From: [Stephen Ubl](#)
To: [Marcia Moermond](#)
Cc: [Nathan Bruhn](#)
Subject: FW: 733 Fairview Ave. N.
Date: Monday, March 11, 2024 1:04:54 PM
Attachments: [image005.png](#)
[image006.png](#)
[image007.png](#)
[image008.png](#)
[image009.png](#)
[image010.png](#)

I have been told that you are engaged in a project at 733 Fairview Ave. N., a building identified as a Vacant Building Category III. If you have questions regarding Plan Review, Permitting, Inspections, or Appeals, please reach out to me and I can see what I can do to move this project along.

**TOUGHRock**

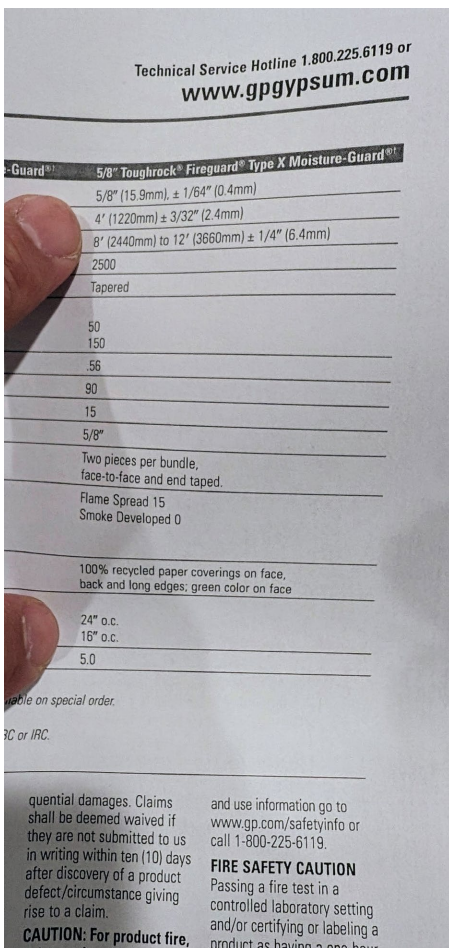
It should be noted, and I want to make very clear since you personally have not been to the home, Stephen, my basement ceilings at the 733 Fairview Ave N home in Saint Paul are **5/8" thick Fireguard (also known as Type X Moisture-Guard), not 1/2" thick**. This is extremely relevant to the forthcoming information to make sure we are on the same page. If, for whatever reason, you do not believe my statement to be correct, I invite you to meet me at the 733 Fairview Home and I personally will show you that I have: 5/8" gypsum board installed in the basement ceilings and not 1/2" thick.

To this end, as illustrated in the Georgia-Pacific manufacturer's installation recommendation instructions for the 5/8" Toughrock Fireguard ("green" board) Type X Moisture Guard gypsum sheetrock that has been installed in the 733 basement ceilings, Framing Spacing, Maximum for Ceilings is **16" o.c., not 12" o.c.**

To this end, the basement 5/8" ceilings at the 733 Fairview Ave. N. property remain in compliance with both the CertainTeed ("purple" board) and the Georgia-Pacific ("green" board) manufacturer's installation recommendations of a minimum of 16" o.c.

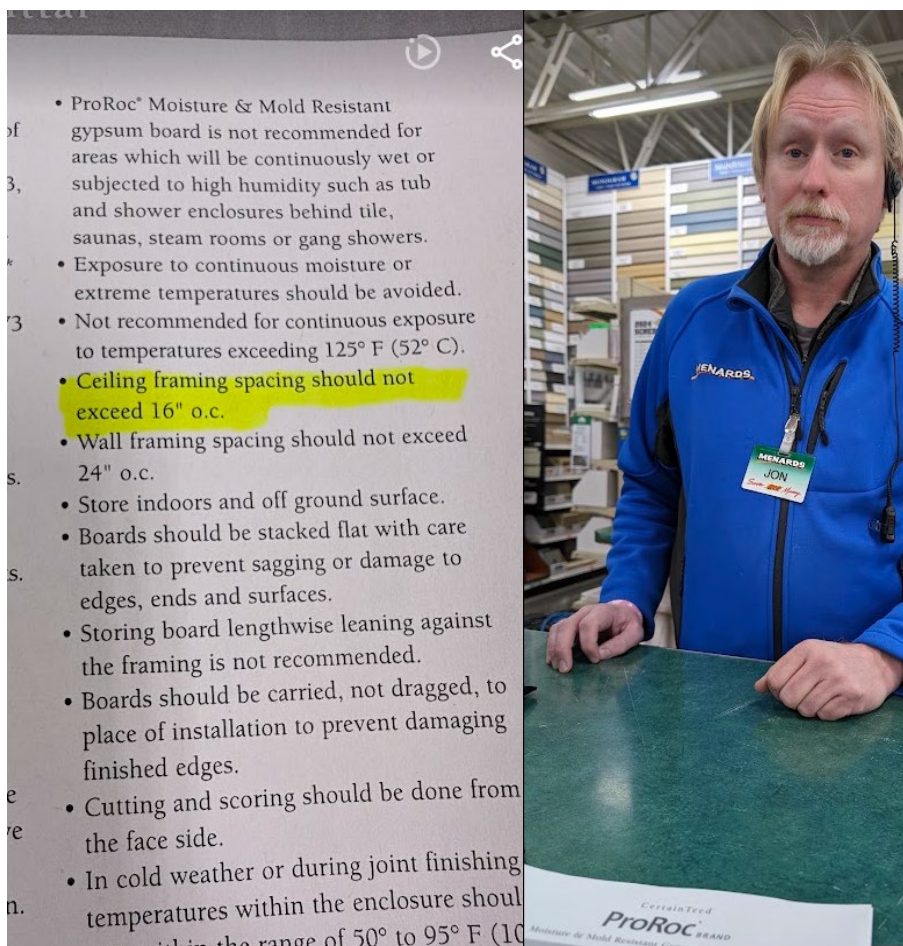
Tuesday, after our meeting, I went to Menards. I eventually was able to speak with Jon, in the building center, who is familiar with my situation. I asked him to provide me with the literature on the manufacturer's installation instructions for the moisture-mold-resistant sheetrock to determine whether what I did in my home complied with the manufacturer's installation recommendations. I asked him specifically whether the moisture & mold resistance gypsum board he sold me from Menards to install on many of the walls and ceilings, per the manufacturer's instructions, called for it to be installed on 16" on center or whether it required a lesser distance. Without saying a word, Jon got on his screen, printed, and with his yellow highlighter, marked the following and slid the paper over to me: "Ceiling framing spacing

should not exceed 16" o.c." Based on the above, I complied with the manufacturer's gypsum board moisture-mold-resistant installation recommendations, Stephen.

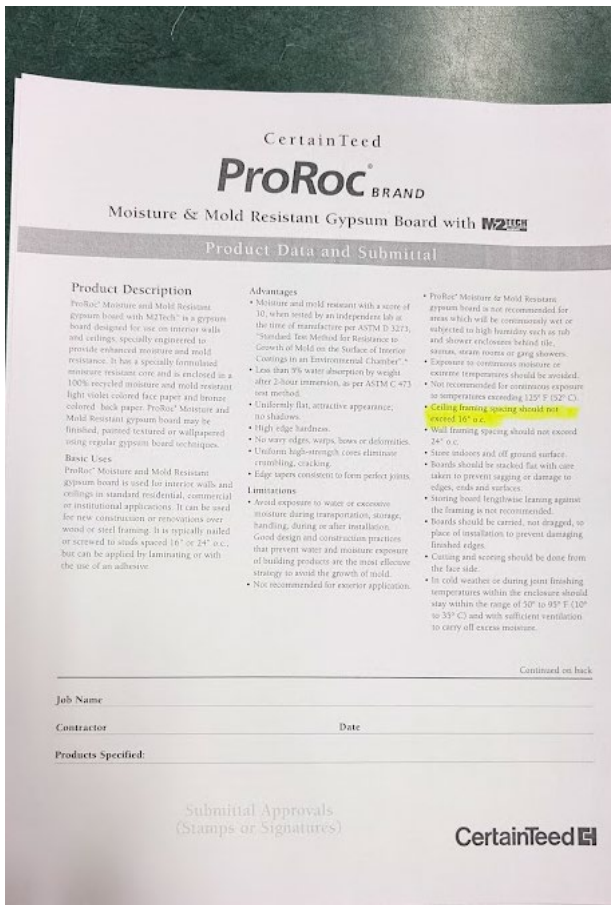
Next, I am sharing with you a series of photos that illustrate the 3 bathrooms in the 733 Fairview Ave. N. home: 1) Main Floor bathroom; 2) Upstairs bathroom; and, 3) Basement bathroom. As I discussed with you, all three bathrooms are entirely done with cement board. In fact, there are additional areas in the home that have cement boards as well. For instance, there is cement board in the Main Floor front entryway, in the Main living room, in the kitchen, in the utility room, in the upstairs landing area, and covering all the flooring areas in the Upstairs and the Main floor.
